SERVICE NEWS

NOVEMBER, 1960

CONTENTS

Fig. 1—Adjusting Corvaire Clutch Linkage

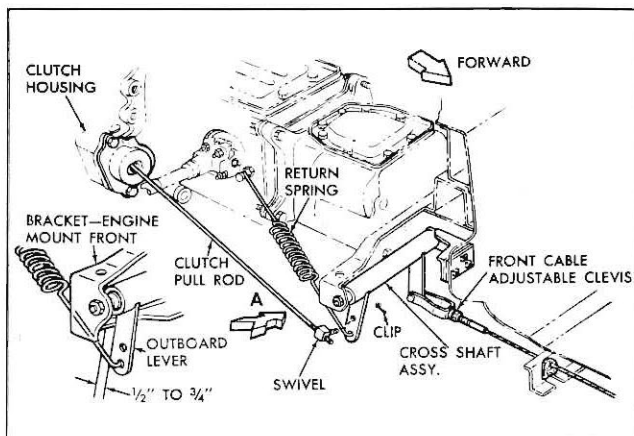
1. Disengage clutch pull rod from cross-shaft.
2. Adjust length of front control cable, at cross-shaft clevis, to obtain $\frac{1}{2}$ " to $\frac{3}{4}$ " spacing between cross-shaft pull rod lever and edge of transmission mounting bracket. (Fig. 1).
3. With pull rod held forward to remove slack at the clutch fork, align rod swivel with upper hole in the cross-shaft lever; then back-off swivel three complete turns and install pull

NOTE: *Lever setting specified in step 2 of "Linkage Adjustment," on page 6B-2 of the 1961 Corvaire Shop Manual is incorrect.*

Fig. 2—1961 Corvair Carburetor Modifications

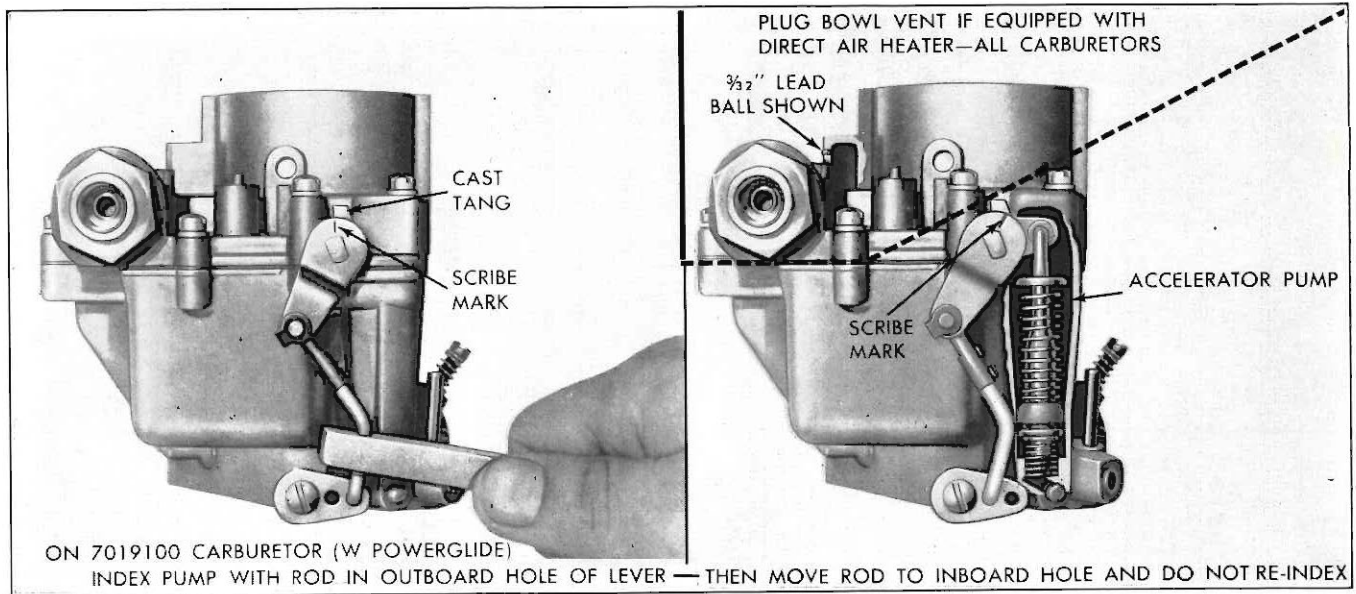
At start of 1961 production on Corvaire and LDFC models, accelerator pump travel on 7019100 carburetor (Powerglide) was found to be in excess

of that required and would therefore produce a flat spot on acceleration. To correct this condition, by reducing pump stroke, production at that time incorporated an inboard hole in the pump actuating lever and attached the link rod at that point.

In many cases, however, after the link rod was assembled in the lever inboard hole, the pump was then re-indexed. This re-indexing defeated the original intent and resulted in the pump having virtually the same capacity as before rework of the linkage.

If a flat spot on acceleration occurs with 7019100 carburetors, which have two holes in the actuating lever, check if the pump is on index. If the pump is on index, it is not properly adjusted and the procedure listed below should be followed to correct the condition.

Corvair and LDFC carburetors (Nos. 7019100, 7019101, and 7019107), when used on vehicles equipped with a direct air heater, have under certain driving conditions emitted gasoline fumes. This odor is carried into the passenger compartment when the heater air mixing valve is opened. The main source of the fuel vapor is a $\frac{1}{16}$ inch external vent hole located in the air horn casting (Fig. 2).

1. Disconnect the pump rod from the inboard hole of the pump lever.
2. Connect the pump rod to the outboard hole of the pump lever (Fig. 2). Bend pump rod to align the pump index mark.
3. Disconnect the pump rod from the outboard hole and connect it to the inboard hole of the lever. The pump index markings should then be disregarded. Do not re-index.

To eliminate objectionable gas odor in vehicles using a direct air heater, the carburetor external vent should be closed with a $\frac{3}{32}$ " lead ball or other suitable soft metal plug.

Fig. 3—Tilt Cab—Chassis Wiring, Transmission Cable Supports, and Splash Shields

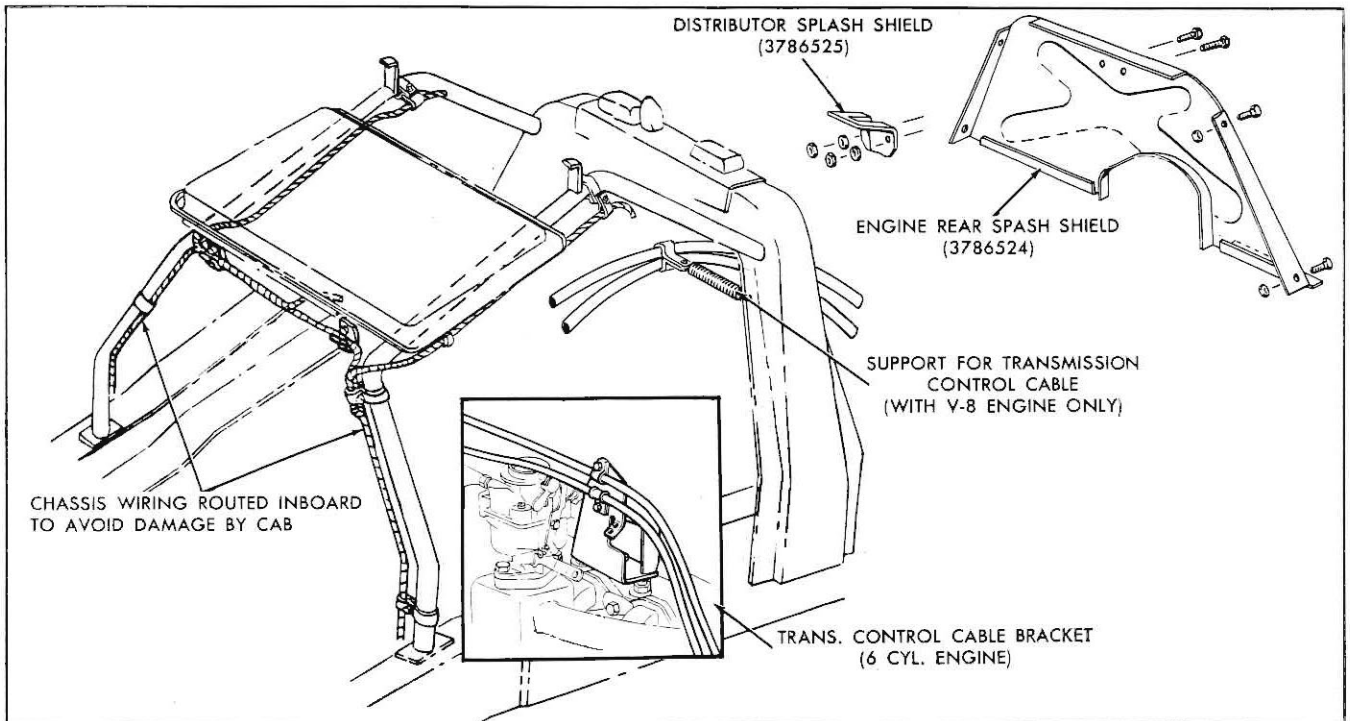
- To avoid possible damage to chassis wiring routed along the transmission control island support legs, the wiring harness leads should be positioned on the inboard side of the support legs, as shown in Figure 3.
- A transmission control cable bracket of the type shown in Figure 29T, on page 10 of the 1960 Tilt Cab Shop Manual, was never used in production. The transmission control cable supports used in 1960-61 vehicles are shown in Figure 3 of this issue.
- To minimize road splash entering the engine

compartment of Tilt Cab trucks, an engine rear splash shield (fig. 3) is now being installed in production. On V-8 engine equipped models, an ignition distributor shield is also being used.

Engine Rear Splash Shield 3786524 and Distributor Splash Shield 3786525 are available, through Chevrolet Parts channels, for installation on 1960 and early 1961 vehicles. When installing Shield 3786524, the shield itself will be used as a template for drilling the attaching screw holes in the cab rear support cross-member.

Fig. 4—Tilt Cab Steering Linkage Adjustment

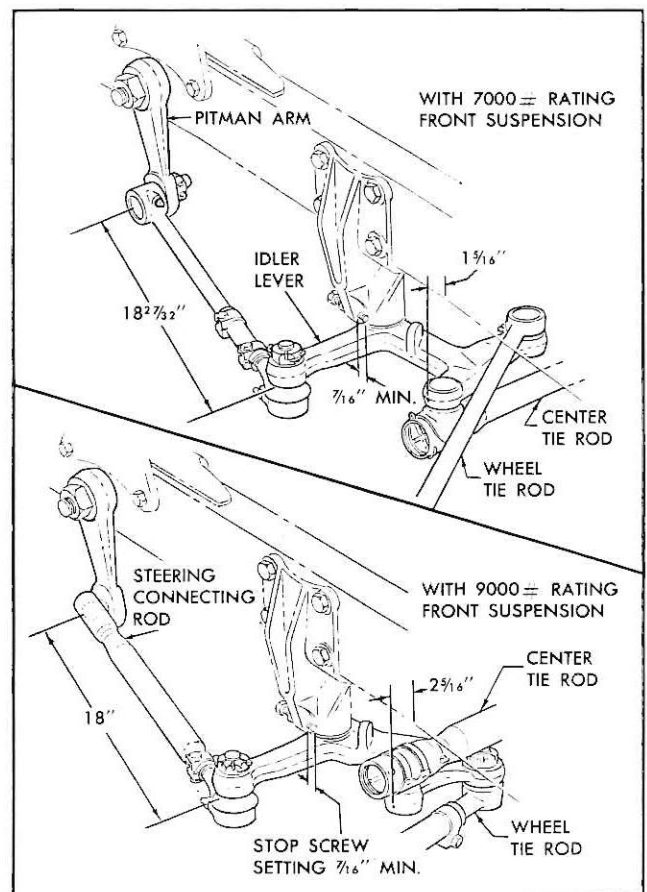
Either a front axle of 7000 pound rating or one of 9000 pound rating is used on 1960-61 Tilt Cab models. Figure 4 provides linkage adjustment specifications for both type axles. Steering linkage adjusting dimensions shown on page 10 of the 1960 Tilt Cab Shop Manual are applicable to only the 7000 pound rating axle; however, the linkage adjustment procedures detailed in the Shop Manual are otherwise applicable to both axles.

Fig. 6—1961 Passenger Car "Deluxe" Heater

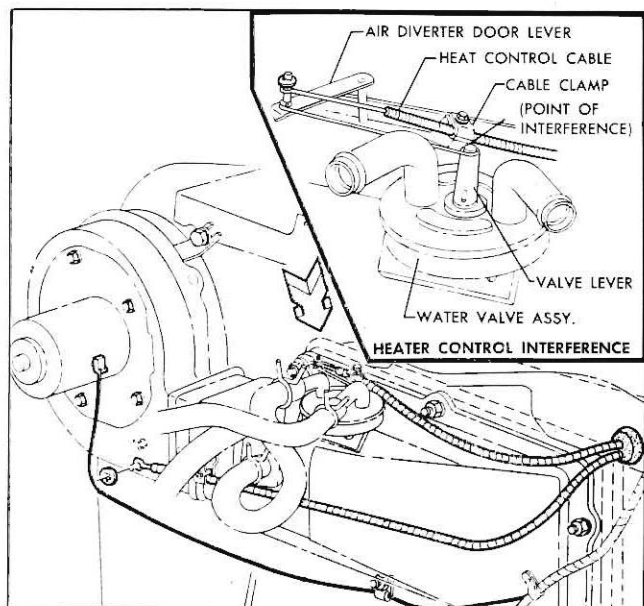
An interference condition present in the control linkage of the "Deluxe" heater on some early 1961 Passenger Cars restricts movement of the controls and results in insufficient heat.

Interference between the water valve lever and the heat control cable clamp restricts movement of the air diverter door and the water control valve, resulting in limited water circulation and air by-passing the heater core.

Correction can be made by bending the control

cable clamp upward to clear the water valve lever (Fig. 6), thereby allowing the controls to travel the required arc.
